## ORIGINATION FORM

### Proposed Revisions to a Standard Plans Index

Index Number: 676-010

Index Title: CABINET INSTALLATION DETAILS

| LAST REVISION<br><del>11/01/18</del> | DESCRIPTION:<br><del>11/01/22</del> |  | FY 2022-23<br>STANDARD PLANS | CABINET INSTALLATION DETAILS | INDEX<br>676-010 | SHEET<br>1 of 1 |

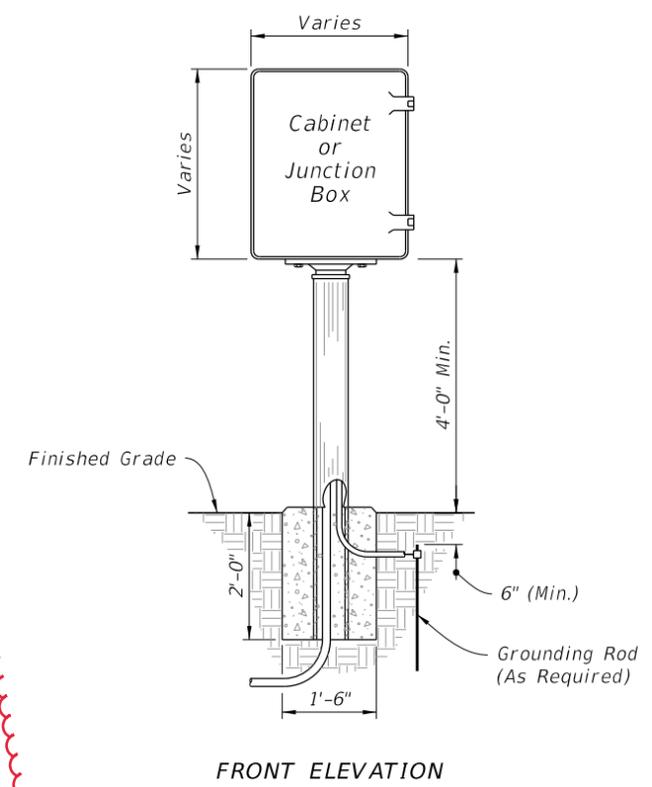
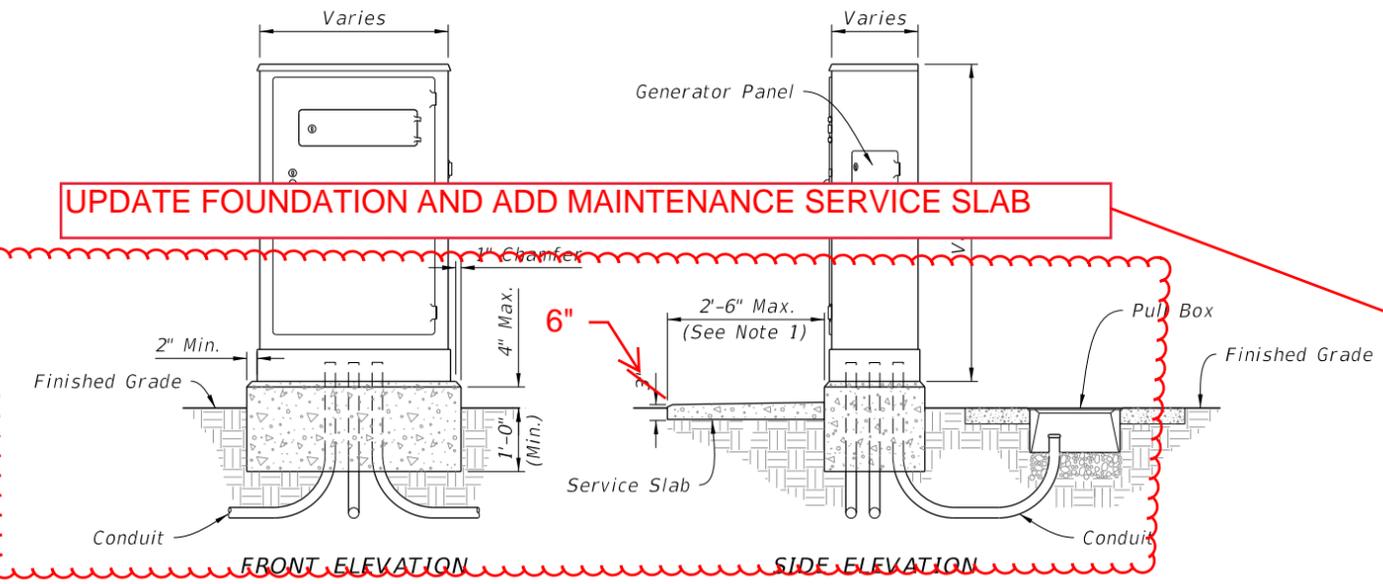
Sheet 1: Changed concrete thickness in the GROUND MOUNTED CONTROLLER CABINET detail; Renumbered sheet.

**MOVED TO SHEET 3**

GROUND MOUNTED INTELLIGENT TRANSPORTATION SYSTEMS (ITS) CABINET

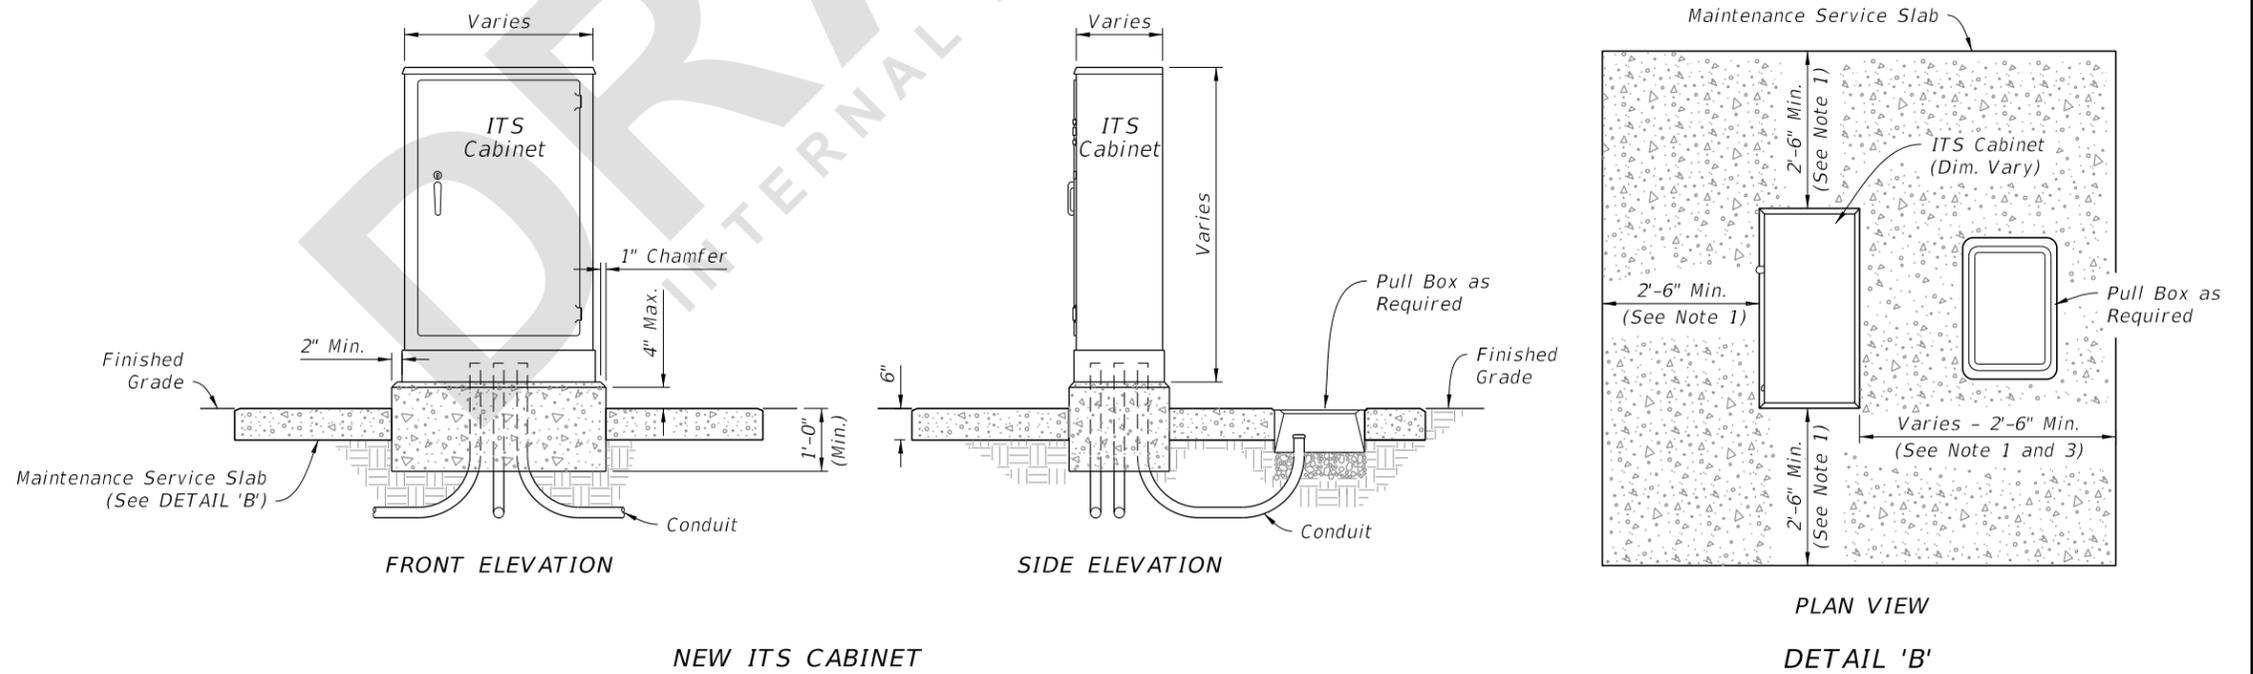
Sheet 2: New Sheet - details for Intelligent Transpiration System (ITS) cabinets and service slab requirements.

3. When a pull box is to be placed within the maintenance service slab, the slab width must be extended to provide for the required pull box apron as detailed in Index 635-001.

4. Coordinate placement of maintenance service slab with proposed final grade. Grade and compact side slopes around the maintenance service slab to provide a stable and level working area and tie into the proposed embankment.

INTERCONNECT JUNCTION BOX

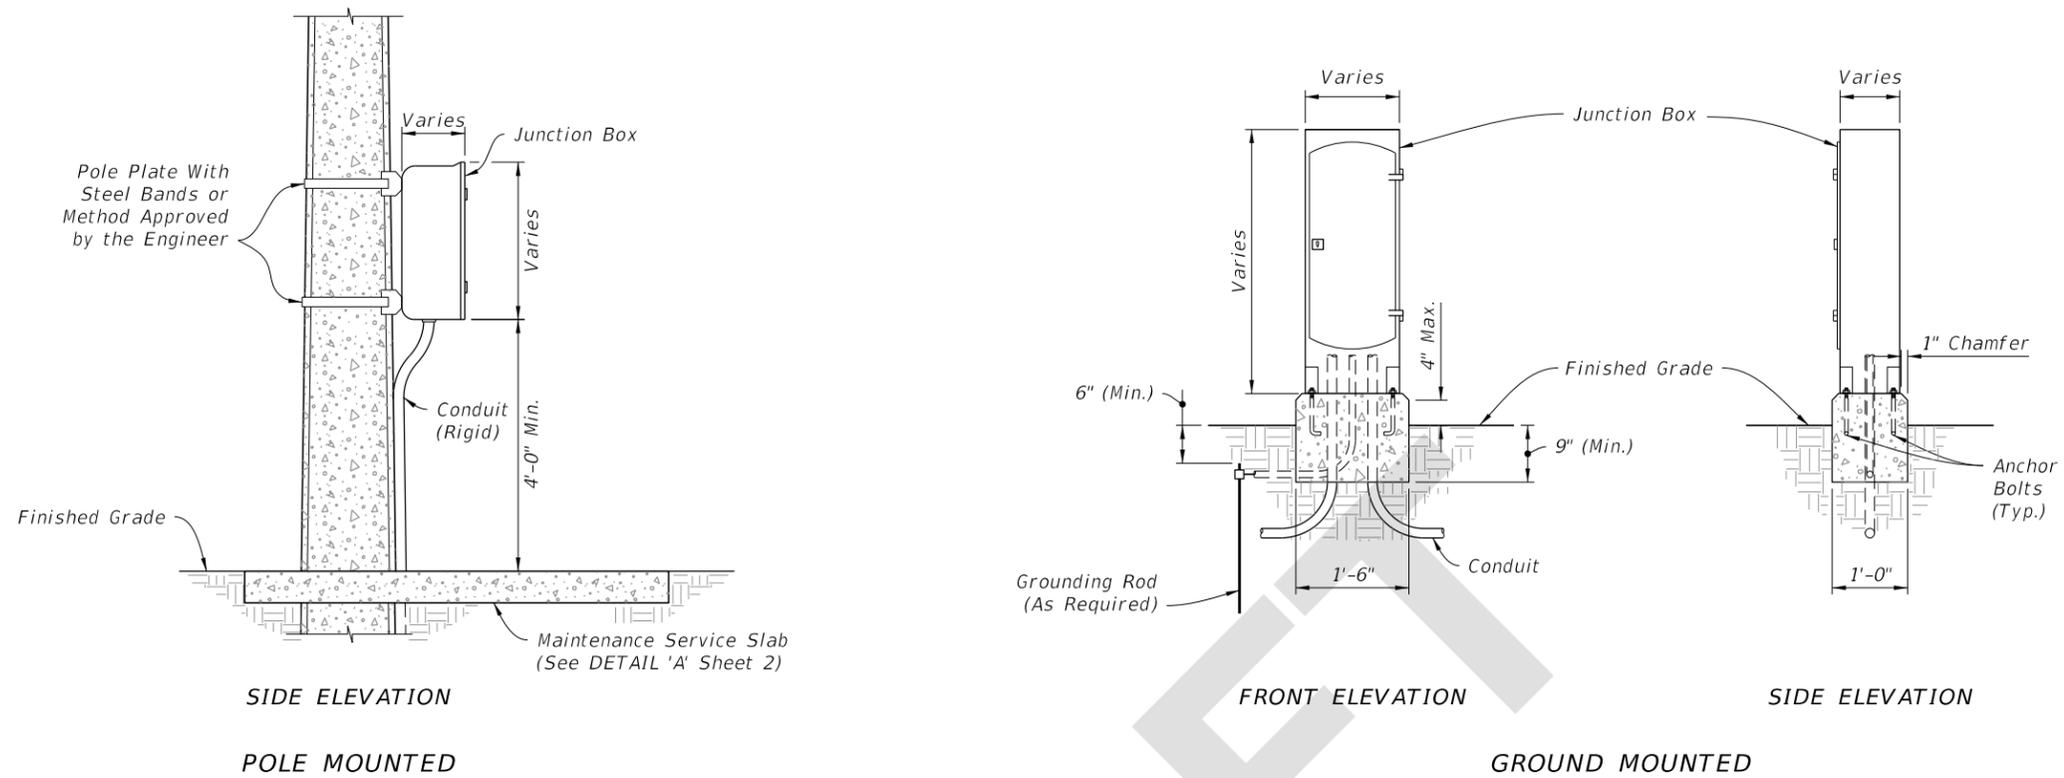
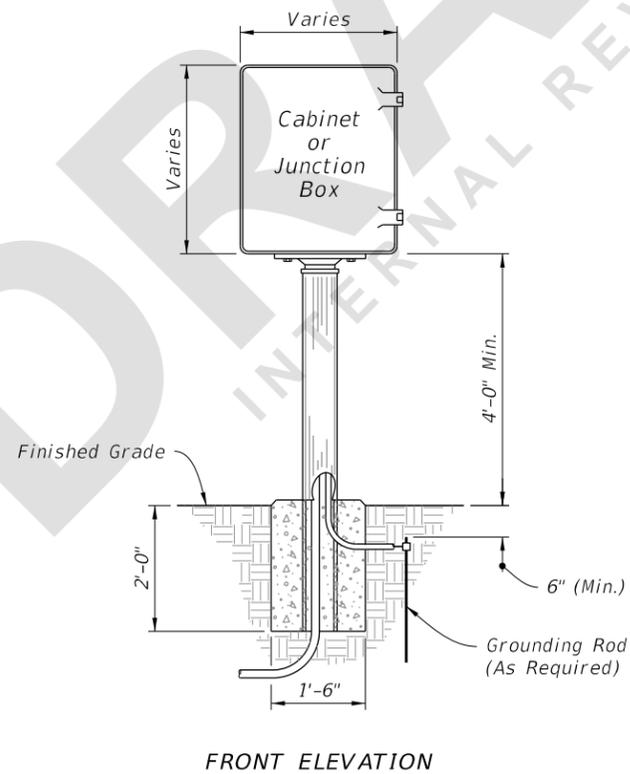
Sheet 3: New Sheet - INTERCONNECT JUNCTION BOX and PEDESTAL MOUNTED CABINET Details.
